Items	Comments	Responds
Comments from Environmental Protection Department dated 17 January 2024		
(a)	Appendix D.2: i. Population and sewage flow of the proposed retail building are inconsistent with that in Table 4.1. Please clarify; and	Appendix D.2 are updated accordingly.

Proposed Flat and Shop and Services Uses with Minor Relaxation of Plot Ratio Restriction at Lots 4614 and 4615RP in DD116, and Lots 1753sBRP (part), 1753sBss3 (part), 1756sA (part), 1756RP (part), 1757, 1758RP, 1760RP in DD120, and adjoining Government Land, Tai Kei Leng, Yuen Long

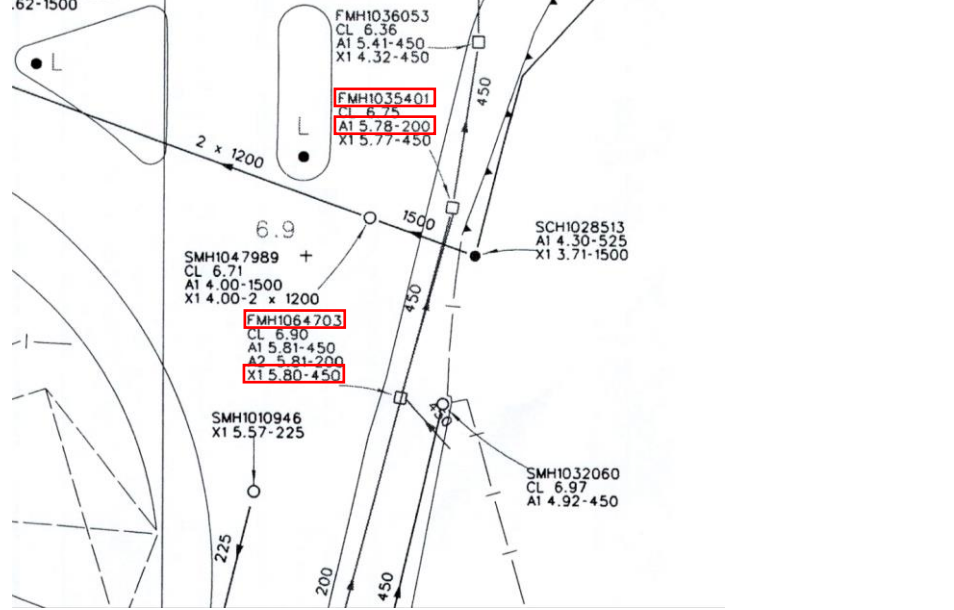
(a)	Section 5.1.3 and Table 5.1: According to our record, the existing sewer between FMH1035400 and FMH1064703 should be 200mm diameter. Please confirm whether the applicant will upgrade this section of sewer at his/her own cost to the Drainage Services Department's satisfaction. Besides, please indicate in the report that the project proponent will be responsible for the implementation of the required upgrading works and the proposed sewerage works, whether within or outside the application site;	Thank you for your kind clarification on the discrepancy between GeoInfo Map and DSD record plan, it is noted that there is an existing 200mm diameter sewer between FMH1035400 and FMH1064703. Also, based on DSD drainage record plan, it is understood that there is only one single existing pipe (450mm dia.) running between FMH1064703 and FMH1035401. However, it is also noted that there is discrepancy on pipe size of the existing pipe between FMH1064703 and FMH1035401 in DSD drainage record plan as shown in below figure.

Items	Comments	Responds
		 <p data-bbox="1155 877 2105 1037">To clarify the size of the existing pipe between FMH1064703 and FMH1035401, drawing from building department (BD) is reviewed and noted that the existing pipe size should be 450mm dia. with an upstream invert level of 5.80mPD and downstream invert level of 5.77mPD in minimum 1 in 300 fall. The BD drawing is extract below for reference.</p>
